Autumn Fields Senior Housing

Enfield, Connecticut

Environmental Review Team Report

September 2001

Figure 4.

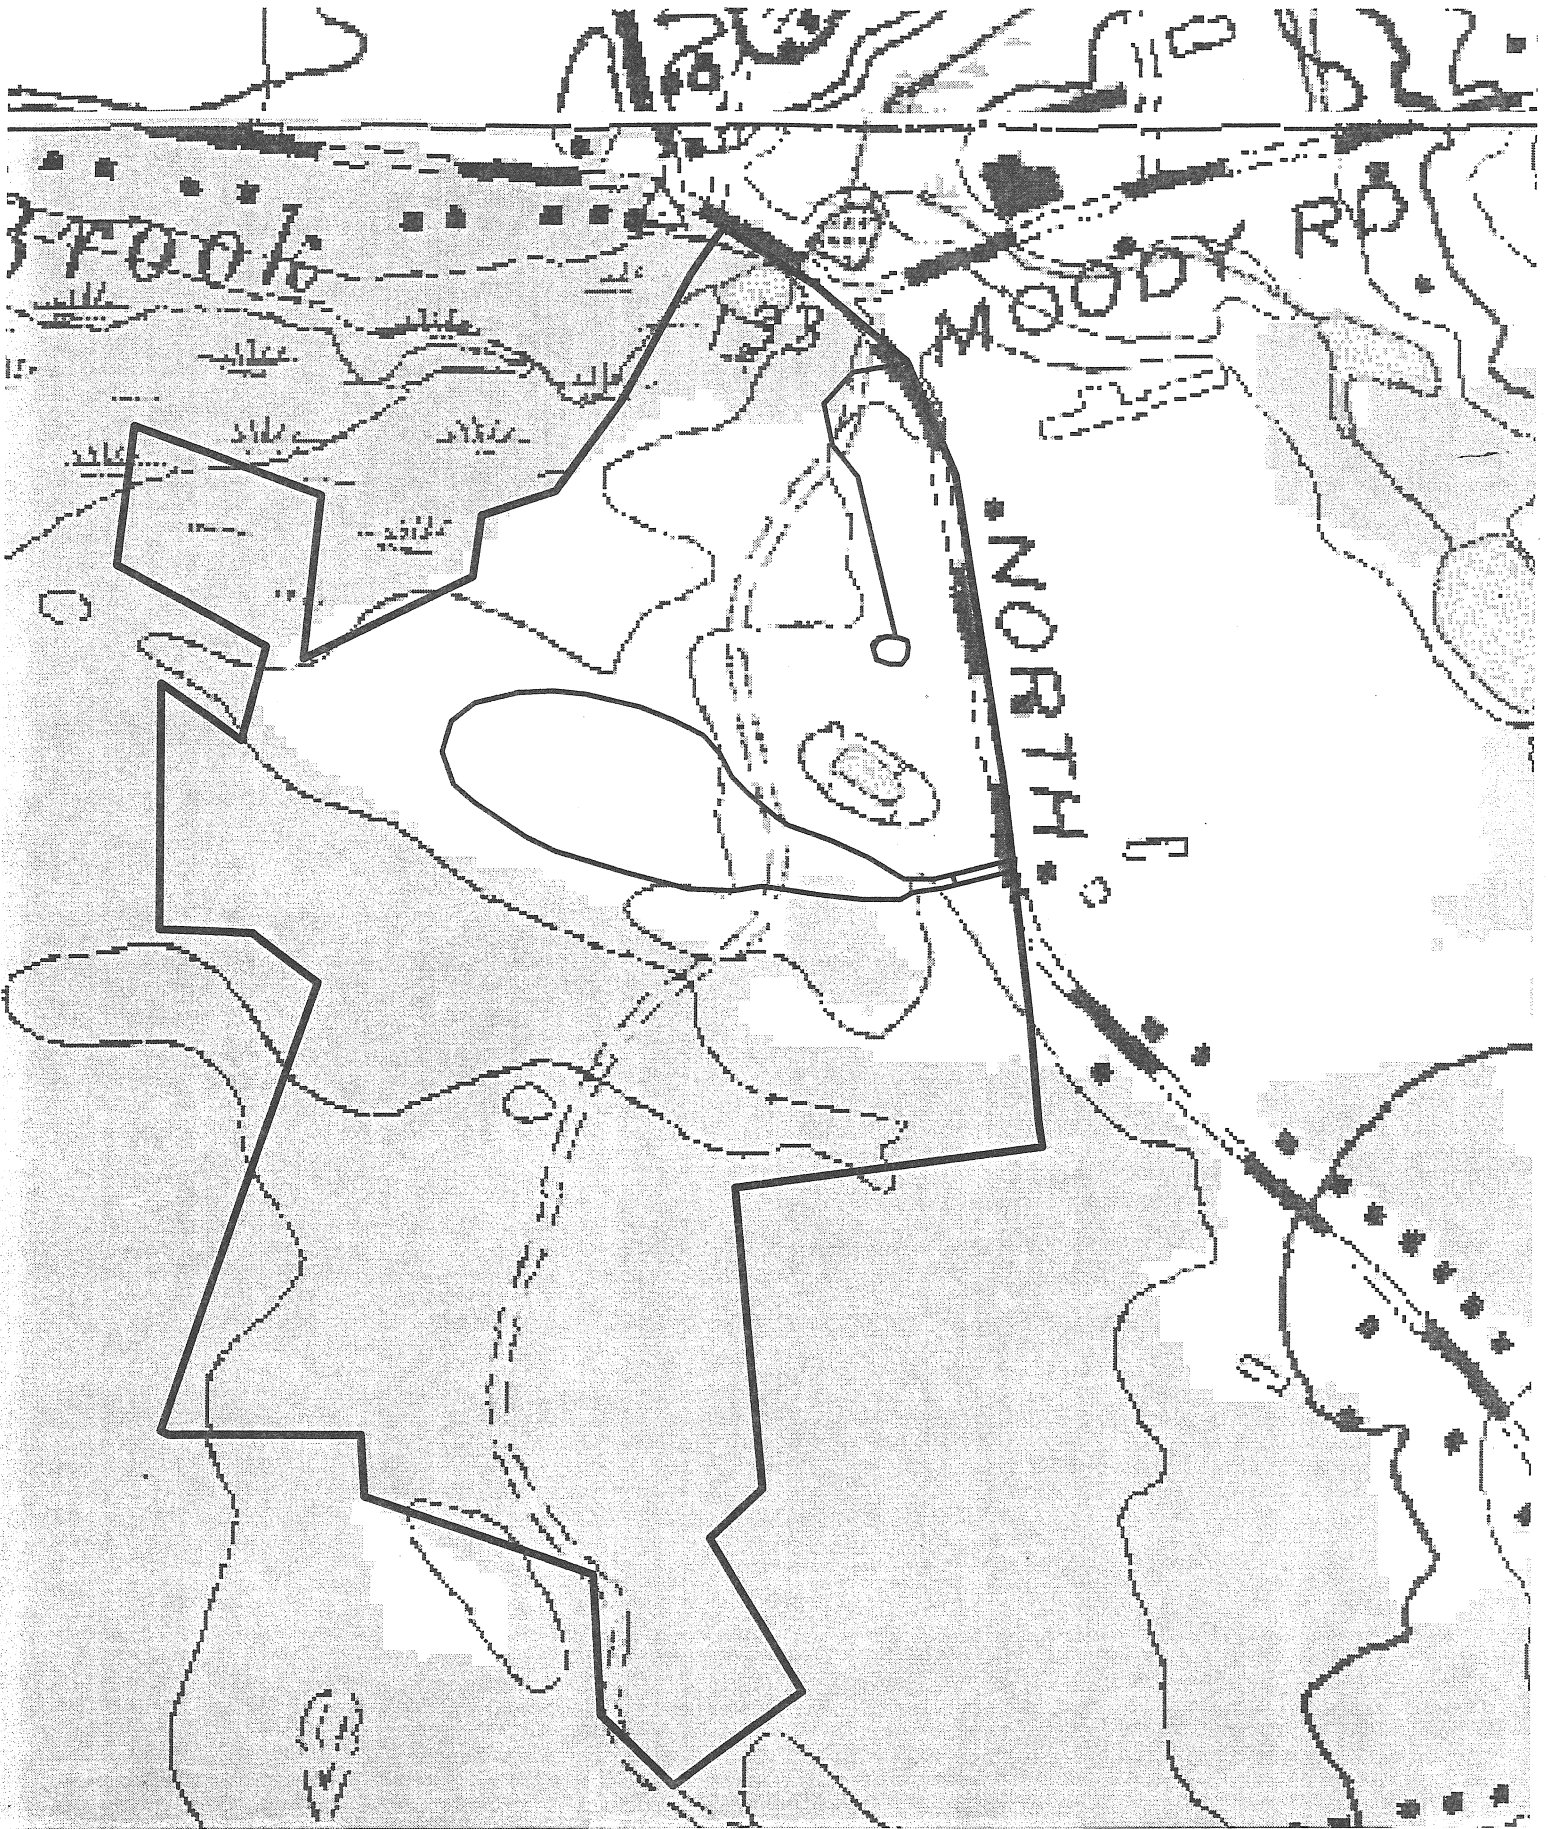
The Team wetland reviewer offers for consideration and discussion the attached alternative proposal (see Figure 4). There are three primary differences between this concept and the proposed road network that the ERT reviewed.

First, the proposed cul-de-sac (Partridge Run) that was off the main road and home to 19 structures has been moved to the north part of the site. In this alternative location the house count would actually be reduced because of the reworking to avoid wetland intrusions. There is an assumption being made that if there was a cul-de-sac with 19 houses permitted the cul-de-sac with fewer houses would therefore be allowed.

Second, the alternative main loop road offers the bulk of residents separate entrance and exit roads. These roads would be parallel in boulevard fashion at the entry with a turn around before the looping begins.

Third, the gap left between the alternative cul-de-sac and the alternative loop road allow for the necessary connection between the vernal pool and the forest wetland. This scenario exchanges the proposed wetland crossing which separates the pool from the forest for a crossing of less wetland value that segments a finger of forested wetland.
